Re: Initial Submission Review: The Aurora Highlands – Preliminary Plat No. 10 and Final Plat
Application Number: DA-2062-16
Case Numbers: 2020-4015-00; 2020-3027-00

Initial Submission Review

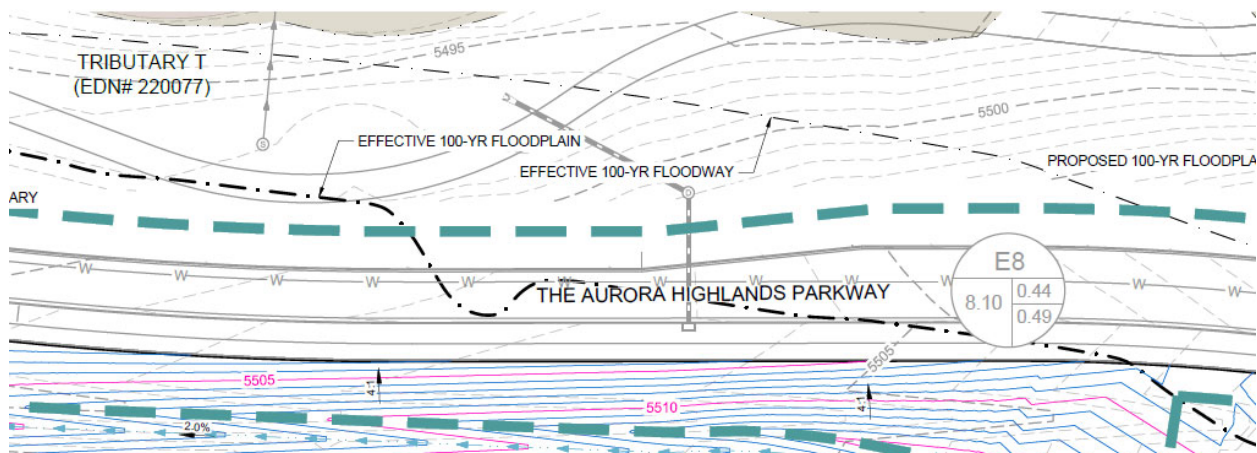
- 1) The addition of EURV Pond 8508S provides an additional outfall to Tributary T. Please ensure a stable outfall at this location as part of final design.
- 2) Please clarify the location of the sump inlet that collects the runoff for Basin E8. Will the inlet shown in the screenshot below capture any runoff or will the entirety of Basin E8 be directed to the sump inlet?
